BUILDINGS ORDINANCE (Chapter 123)
(Section 35)

**Superseding Order by the Building Authority under section 26A(1)
of the Buildings Ordinance (Cap. 123) and under section 46
of the Interpretation and General Clauses Ordinance (Cap. 1)**

Order No. INVO0008/K/23/TF

To : Owner(s) of
FLAT NO. 131 ON 1ST FLOOR
PEONY HOUSE WEST BLOCK
NO.12 FOO KWAI STREET KOWLOON

1/F 平面圖
1/F PLAN

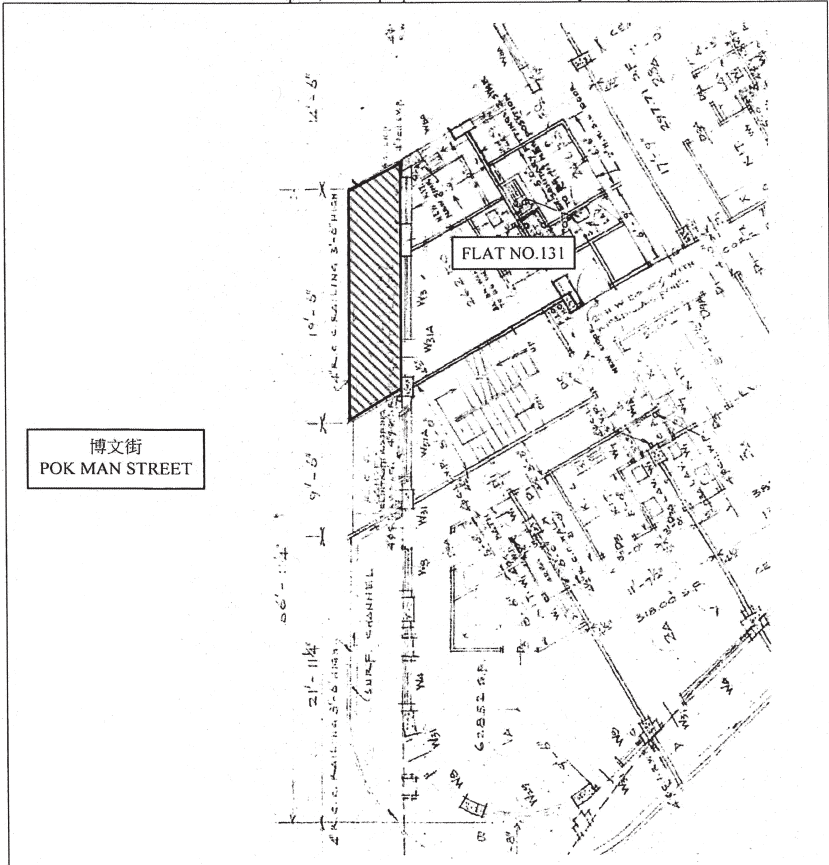
- (i) Investigate and report on the structural integrity and stability of the cantilevered slab balcony of the premises. The investigation report should include the following information:-
 - (a) The layout of the existing steel reinforcing bars, diameter of the main steel reinforcing bars and the thickness of protective concrete cover;
 - (b) The thickness of structural slab and screeding;
 - (c) Degree of corrosion of steel reinforcing bars and carbonation of concrete;
 - (d) Compressive strength of concrete; and
 - (e) Calculation to justify the factor of safety against failure.
- (ii) Submit proposals for remedial works if the structures are found to be structurally inadequate, or do not possess adequate factor of safety against failure.

(The location of the cantilevered slab balcony described above is shown hatched-black on the plan annexed hereto, for the purpose of identification only.)
